ADDENDUM NO. 2

PROJECT: Bannack State Park Visitor's Center Septic System Replacement

FWP PROJECT #: 7196148

DATE: March 17, 2023

MONTANA FISH, WILDLIFE & PARKS
 SITE PLAN & OVERALL WASTEWATER IMPROVEMENTS
 BANNACK SP 4200 BANNACK ROAD, DILLON, 59725

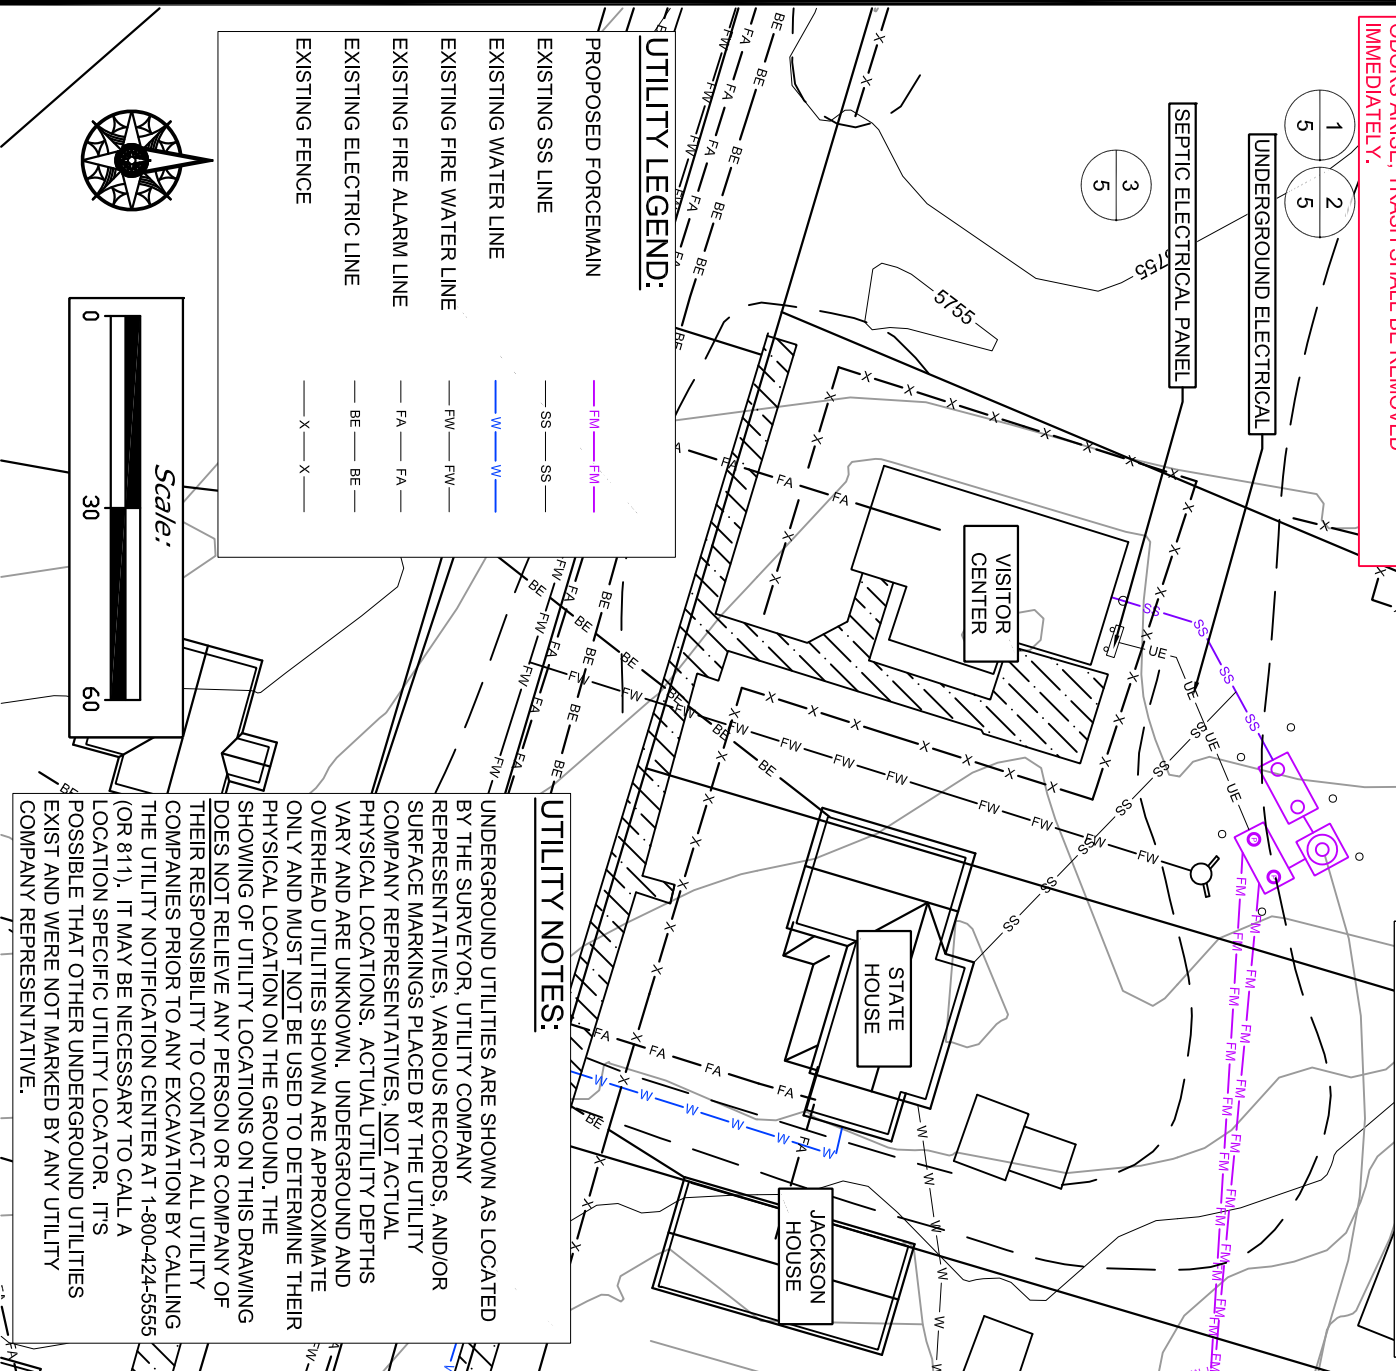
8. The existing 4" sewer line between the septic tank and visitor's center has experienced freezing this winter. The revised plans now require the contractor to replace the existing 4" sewer service line between the foundation wall and the existing septic tank. Rigid polystyrene (blueboard) insulation must be placed over the new sewer service line prior to backfill.

REPLACE EXIST 4" PVC S.S. SERVICE FROM NEW COTG TO EXIST SEPTIC TANK INSULATE ENTIRE LENGTH

**ELECTRICAL REQUIREMENTS
 BANNACK SP 4200 BANNACK ROAD, DILLON, 59725**

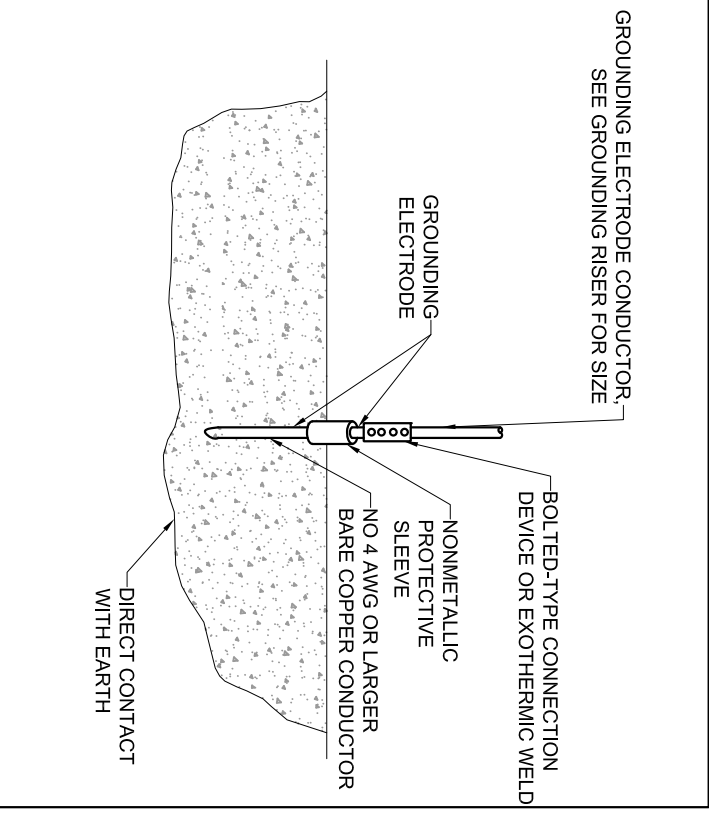
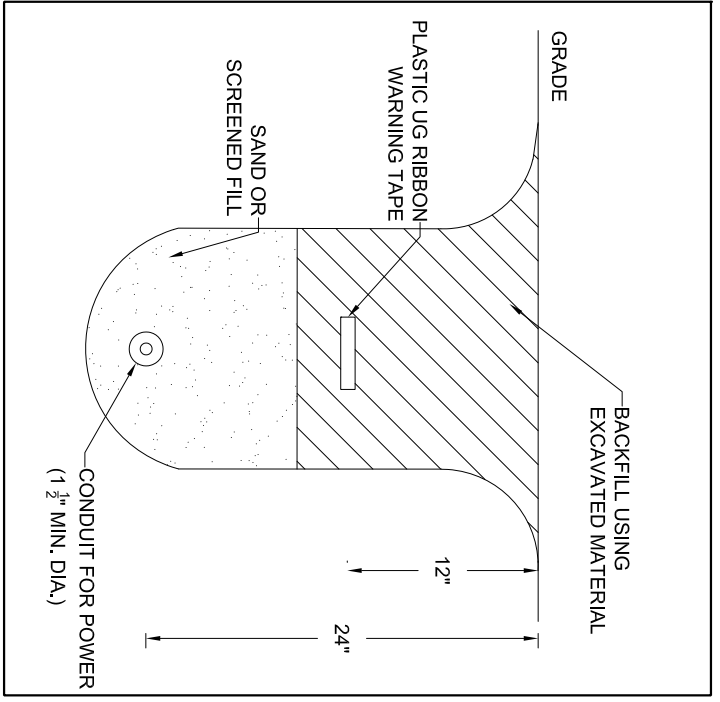
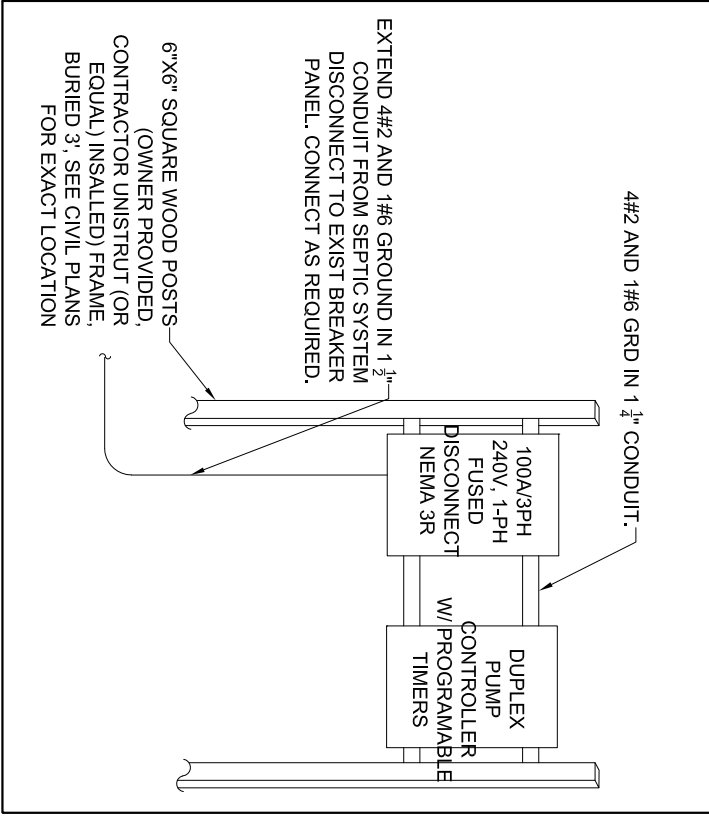
1. Source power available at the site has been confirmed to be 240V, single-phase. Plans and Specification Section 02810 have been revised to reflect this.

2. The duplex dose pump control panel is to be supplied by the contractor and not "BY OTHERS" as noted on the plan sheets. Plans have been updated to reflect.

3. The duplex dose pump control panel (alternating) must be equipped with programable timers per the project specifications.
4. The electrical ground detail on Plan Sheet 2/5 has been revised.
